**UN Regulation No. 48 (Installation of lighting and light-signalling devices)**

### **Proposal for Supplement 2 to the 05 series of amendments**

#### **Submitted by the expert from Poland\***

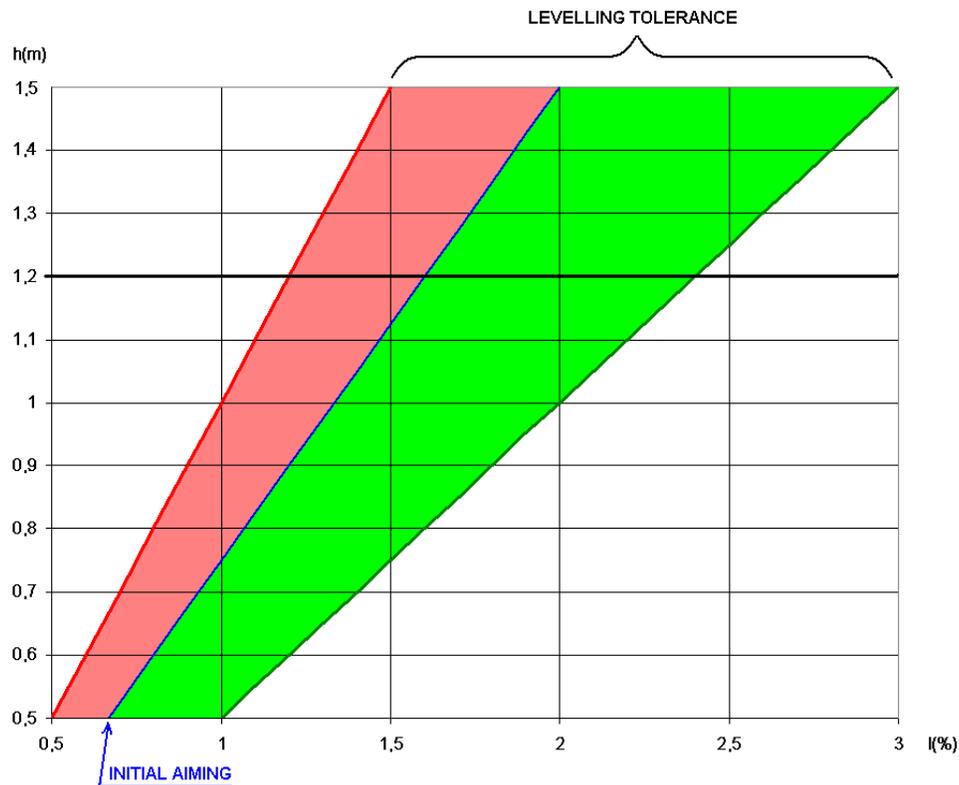
"6.2.6.1.2. Depending on the mounting height in metres (h) of the **dipped-beam headlamp reference axis, the vertical inclination of the cut-off of the dipped beam, (in the direction of the reference axis) measured on the unladen vehicles, taking in account 0.1 per cent accuracy, shall have the value of initial aiming for which the horizontal part of cut-off crosses the surface of flat horizontal road at the distance of 75 m from the headlamp.**

**The aiming limits under all the static conditions of Annex 5 should be such that the distance of crossing of the vertical part of cut-off with road surface shall remain between [50 m] and [100 m].**

The above limits and the initial aiming values are summarized in the diagram below.
